## Scientific Review

The scientific review included 13 individuals from the following disciplines: wildlife biology (3), aquatic biology (3), silviculture (2), soils (2), and forest ecology (3). Reviewers were asked to rank the proposed changes relative to the existing guidelines for each of the 4 revision categories (Infrastructure, biomass guidelines, leave trees, and RMZ guidelines) with the following questions:

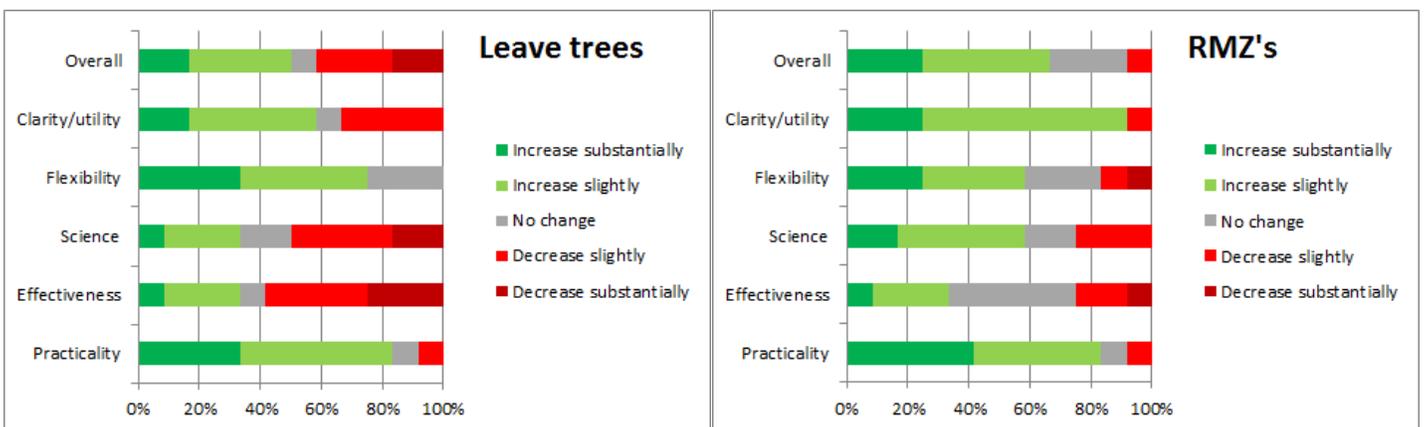
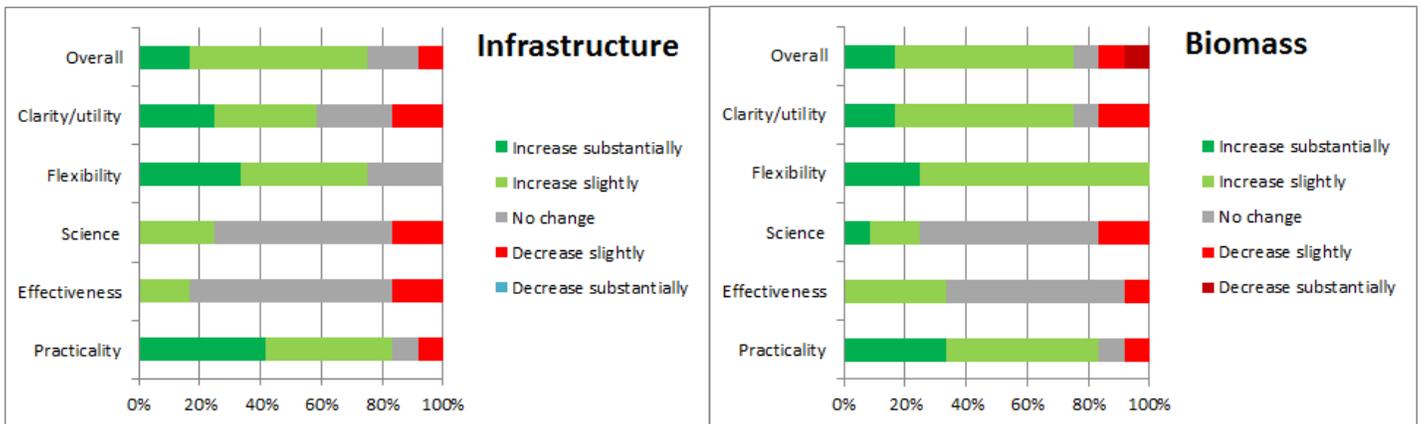
The following figures show the scientific reviewer responses to these questions with each change ranking displayed as a percentage of the total response. Categories with predominantly green colors indicate increases, while those in red indicate decreases (e.g., decreased scientific basis relative to the current guideline)

There was a divergence of views on the leave tree recommendation (reflected in the chart above)
